V2500-A5 PROPULSION SYSTEMS SERVICE BULLETIN

V2500-ENG-73-0225

ENGINE – FUEL AND CONTROL – PLUG, DATA ENTRY – MODIFICATION TO PERMIT A MORE OPEN
VARIABLE STATOR VANE SCHEDULE

GROUND PIN LOCATIONS
Figure 1

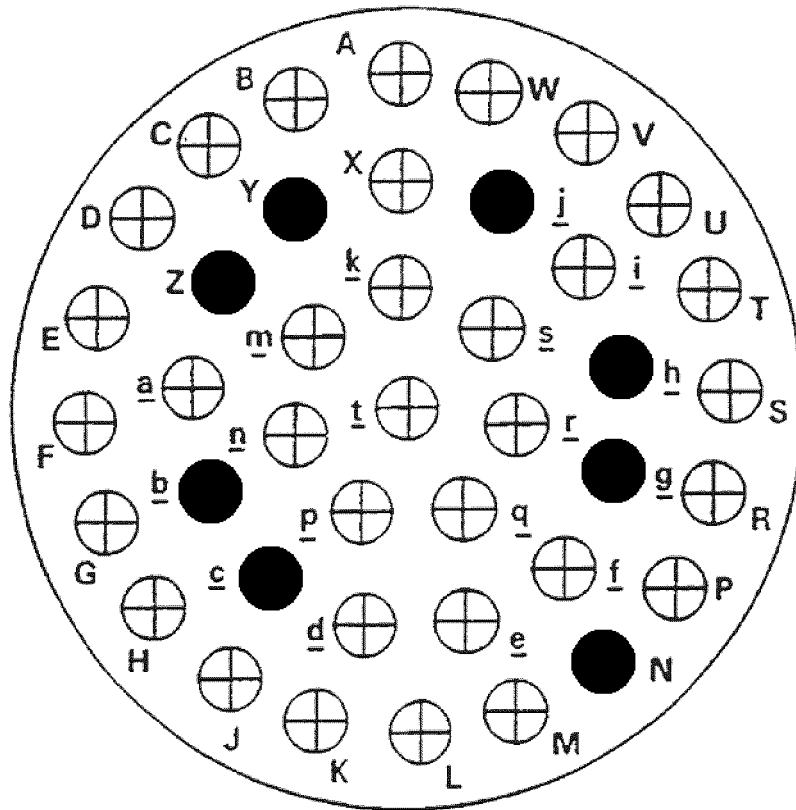
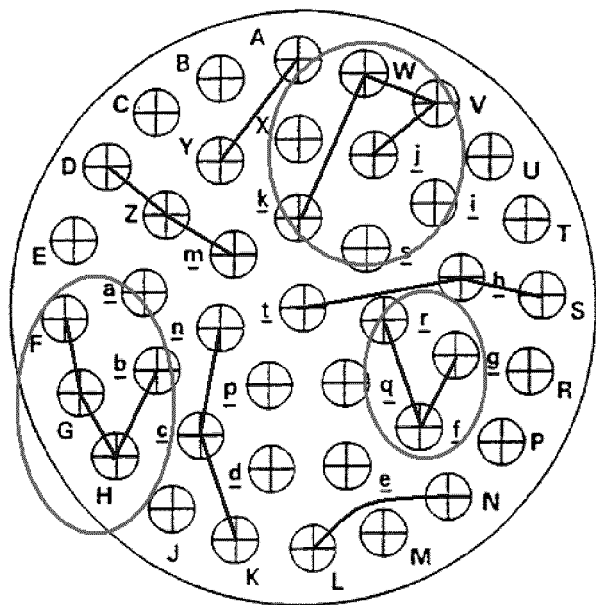
CAUTION: WHILE RE-WIRING THE DATA ENTRY PLUG PER FIGURE B FOR NEW ENGINE VARIANT, DO NOT DISCONNECT THE GROUND PINS. SEE FIGURE 1 FOR GROUND PINS IN THE DATA ENTRY PLUG.

NOTE: The black dotted letters - Y, Z, b, c, j, h, g & N are ground pins

NOTE: While re-wiring the DEP for a new engine variant, make sure that the jumper pins are connected to its corresponding ground pins.

CORRECT MARKING EXAMPLE
Figure 2

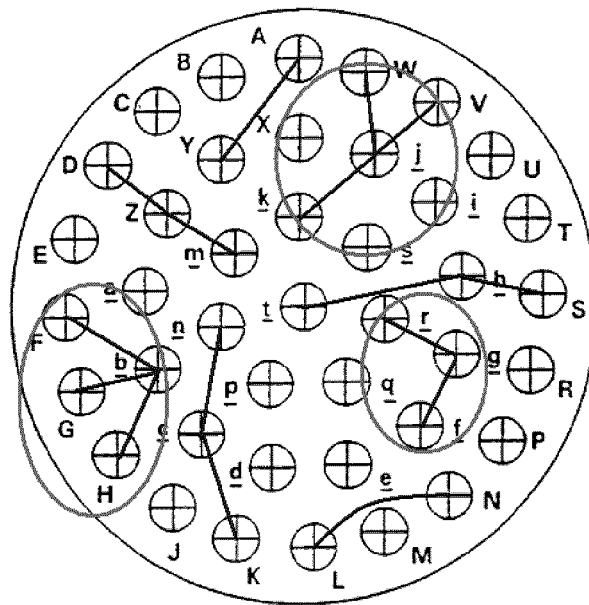
- (iv) EPR modifier and Bias
 - (b) Mark the existing Data Entry Plug connections on the diagram in Figure A. After marking the existing Data Entry Plug wiring in Figure A, make sure all the connections originate from the ground pin to the non-ground pin. If not, re-arrange the marking to meet this requirement. See Figure 1 for an illustration of which pins are the ground pins. See Figure 2 for an example of correcting the marking of the Data Entry Plug diagram. The illustration shown in Figure 2 is only an example that utilizes 27K rating but the concept of correct marking applies to all engine ratings.

NOTE: The above illustration (left side) shows the incorrect marking between ground pins b, g, and J, and non-ground pins. The right side shows correct marking.
